TYPICAL SECTION SHEET	PROJECT NAME: WINDSOR - HARTLAND	
	PROJECT NUMBER: IM 091-(161)	
	FILE NAME: p07al42.dgn	PLOT DATE: 16-AUG-2011 13:41
	PROJECT LEADER: D.E.G.	DRAWN BY: C.A.K.
	DESIGNED BY: M.J.L.	CHECKED BY: R.A.B.
	IPARM FILE: p07al42+yp.i	SHEET 3 OF 56

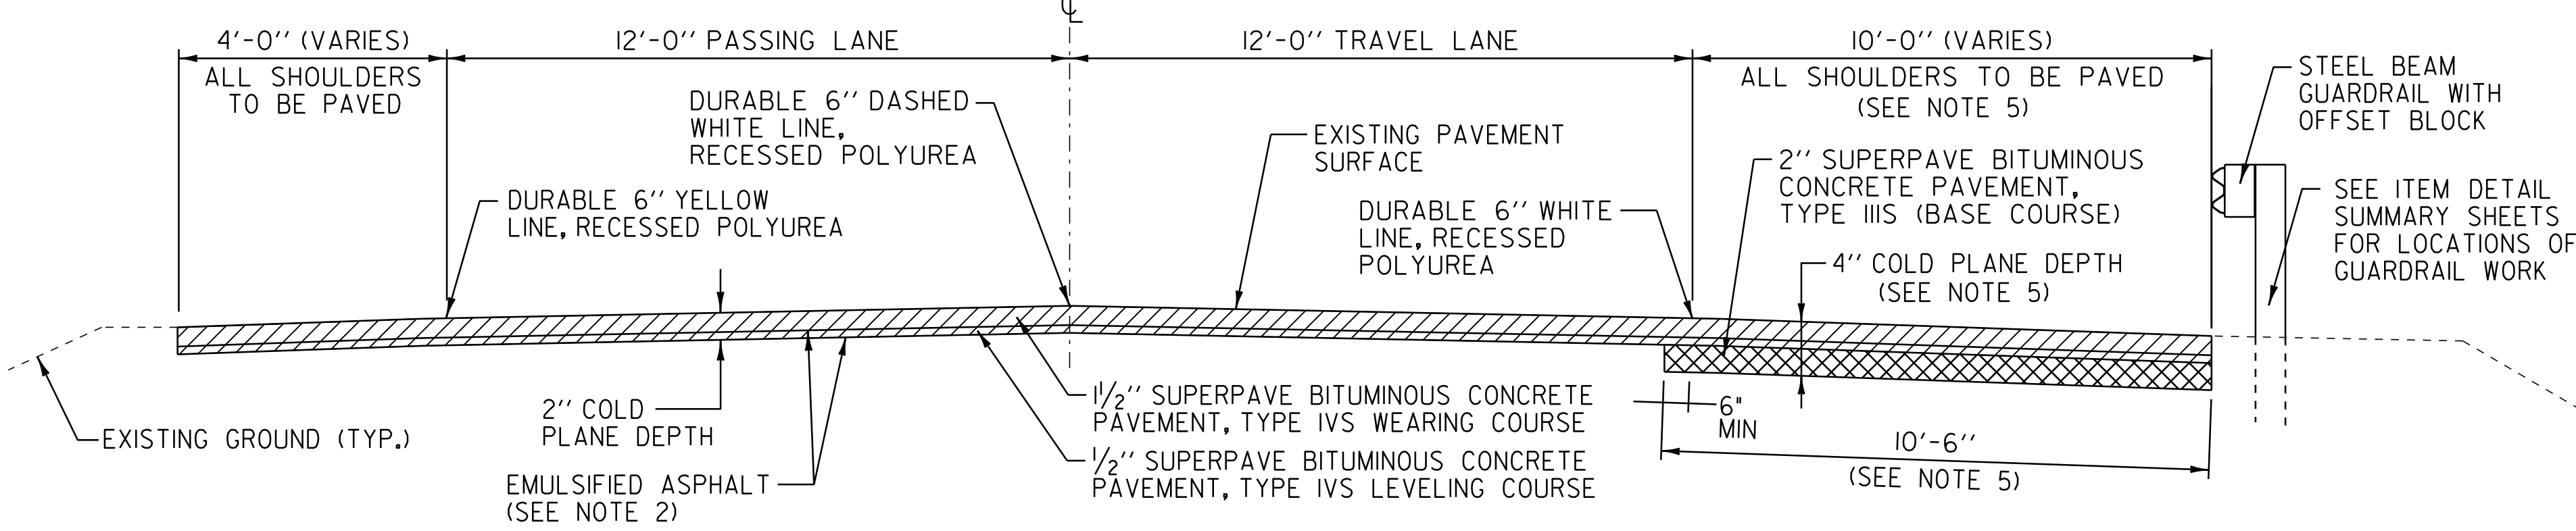
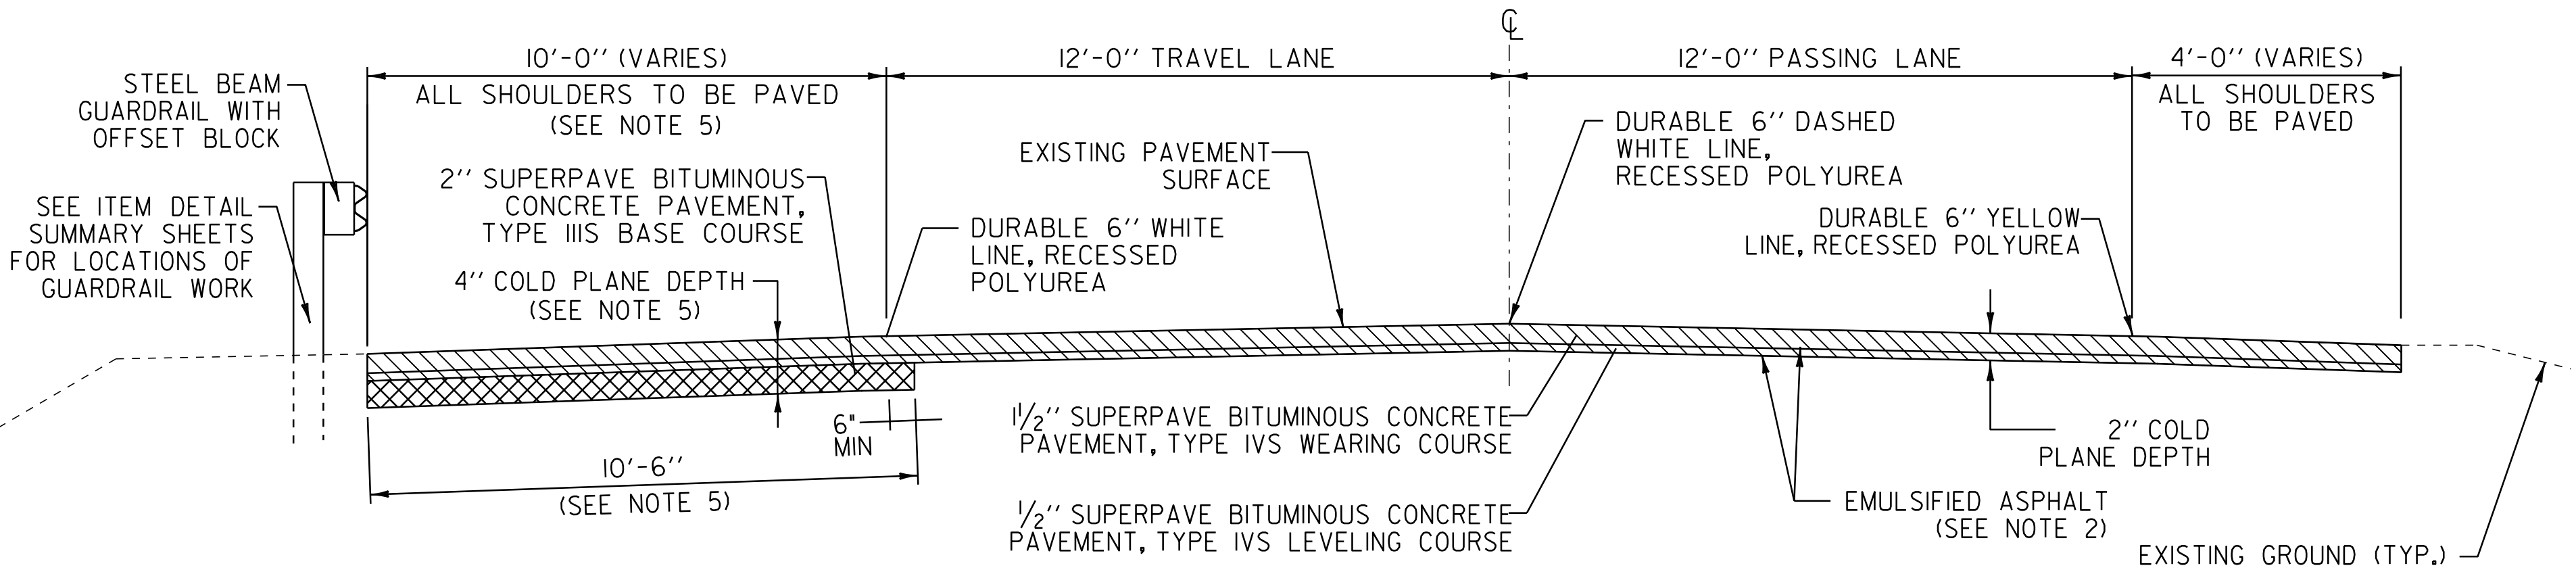
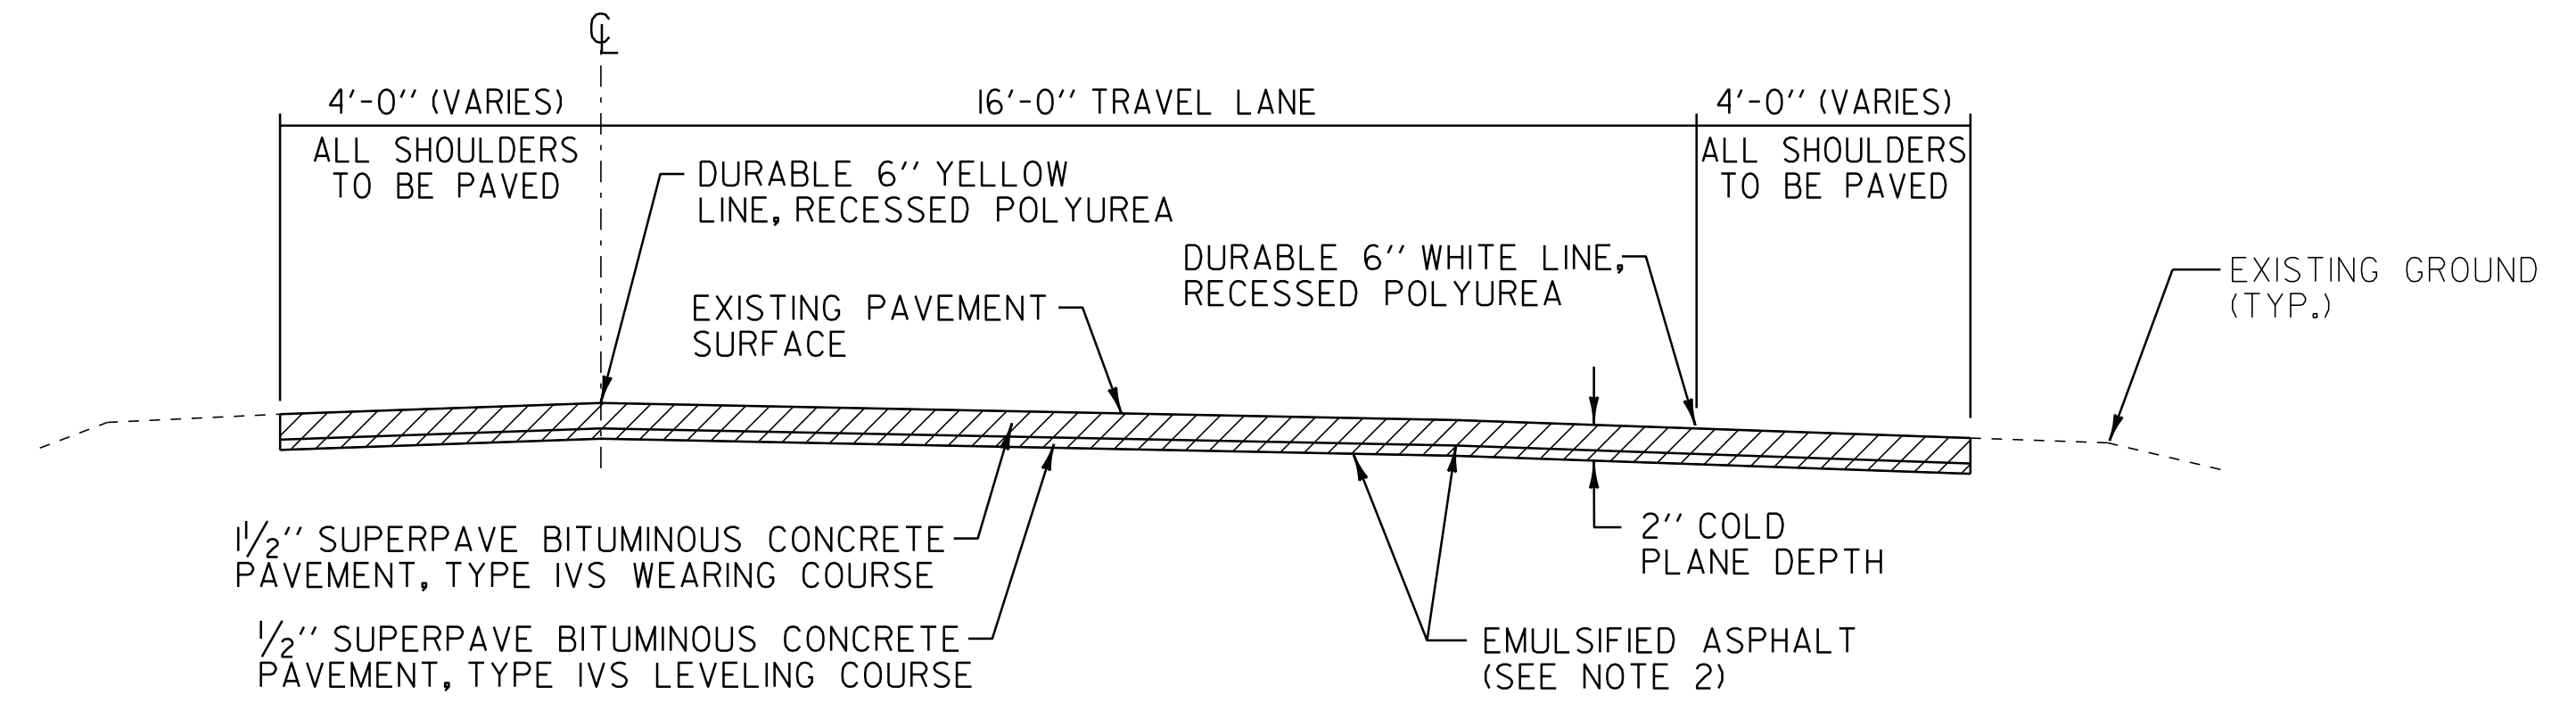
- ALL DI'S AND CB'S TO BE REHABILITATED AS SHOWN ON THE PLANS AND PAID FOR UNDER 604.412, 604.415, 604.418 REHAB. DI, CB OR MH CLASS I, II, III, SHALL BE RAISED OR REHABILITATED SUCH THAT THE NEW GRATE ELEVATION IS ~~LEVEL~~ WITH THE SURROUNDING TERRAIN. TYPE B GRATES SHALL BE USED FOR ALL REHABILITATED DI'S AND CB'S IN PAVEMENT ADJACENT TO BITUMINOUS CURBING. DRAINAGE STRUCTURES CALLING FOR REHAB HAVE BEEN EVENLY DISTRIBUTED BETWEEN ITEMS 604.412, 604.415, AND 604.418 FOR ESTIMATING PURPOSES. **3/4" BELOW**

*** PRECONSTRUCTION AND POST CONSTRUCTION HEIGHTS WERE RECORDED AND FILED IN PROJECT COMPUTATIONS BINDER IN SECTION 490.30**
